CITY OF BAINBRIDGE ISLAND

Re: Wallace Way Cottages Tier II HDDP PLN 50589 PRE Pre-application Conference Summary

Preliminary Notification of Qualification

Subject: PLN50589B PRE – Wallace Cottages

SHEET: A-1

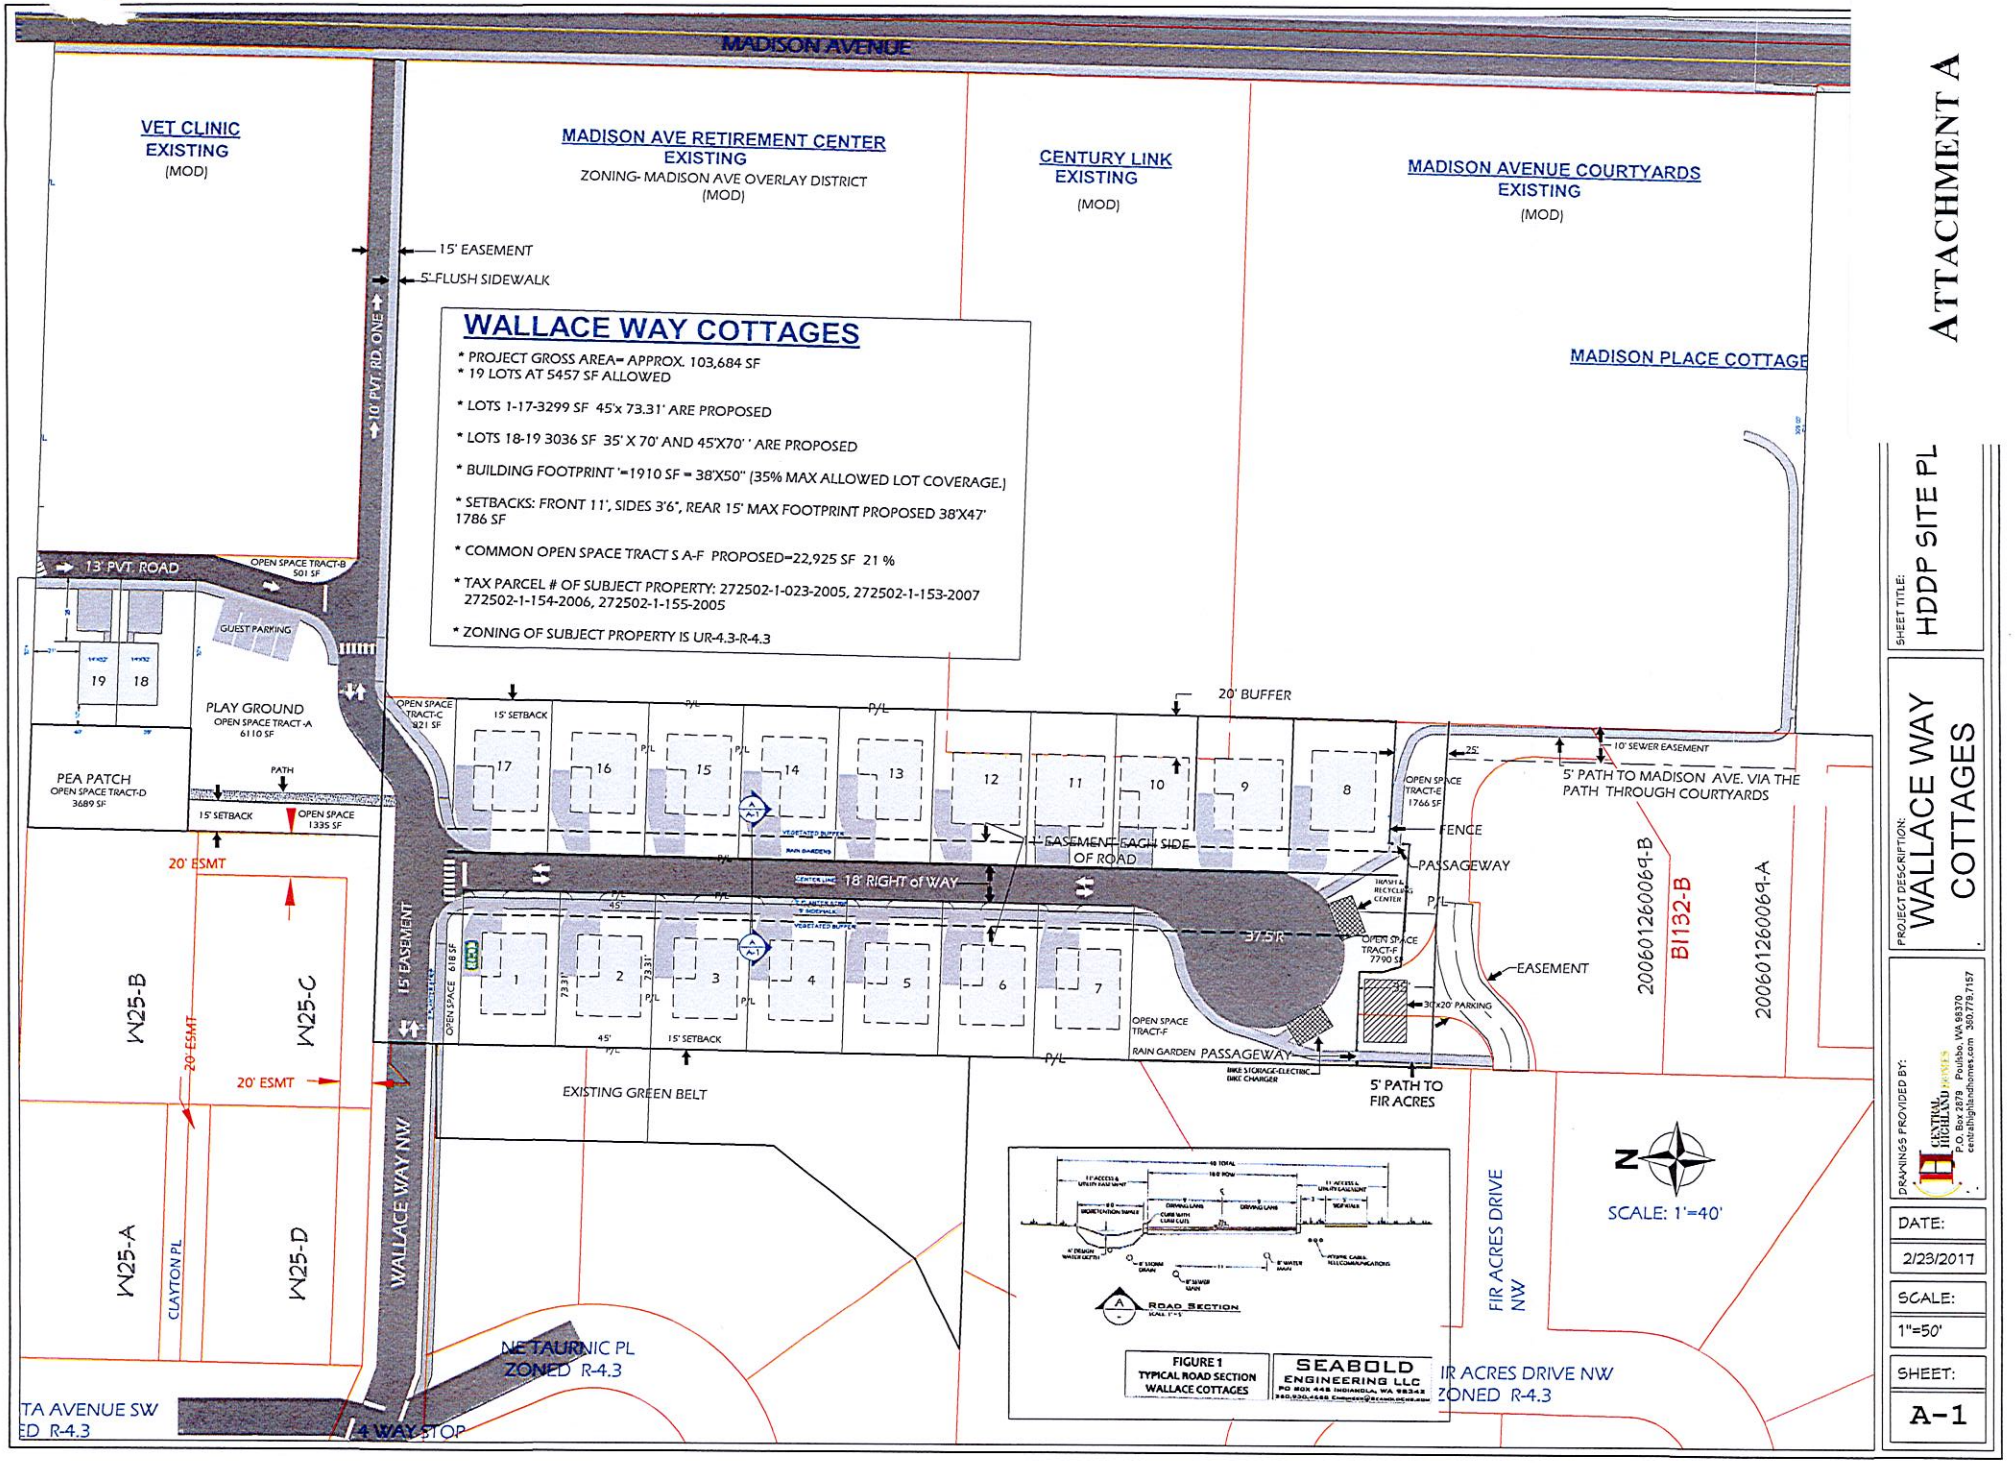
2. The proposal includes a spur road for a future connection to the north. Any project located to the north has not been proposed with the preapplication materials and cannot be considered for cumulative impacts or mitigations with regards to traffic and pedestrian circulation. Remove any spur connection to the north from the proposal.

16. Sanitary sewer main extension shown as 'SS Alternate Route – A' in the pre-application civil plans ties into an older clay pipe system. Routing the sanitary to this system would require an assessment of the its existing condition and remaining life of the system. 'SS Alternate Route – B' should be considered as the most feasible routing.

1) Provide bollards rather than a gate at the south road end emergency access to accommodate peds and cyclists.
2) Support the east-west connectivity from Madison to Wallace.

2. The proposed cul-de-sac is acceptable.

3. The elimination of the crash gate and access to Fir Acres is acceptable with the proposed cul-de-sac.
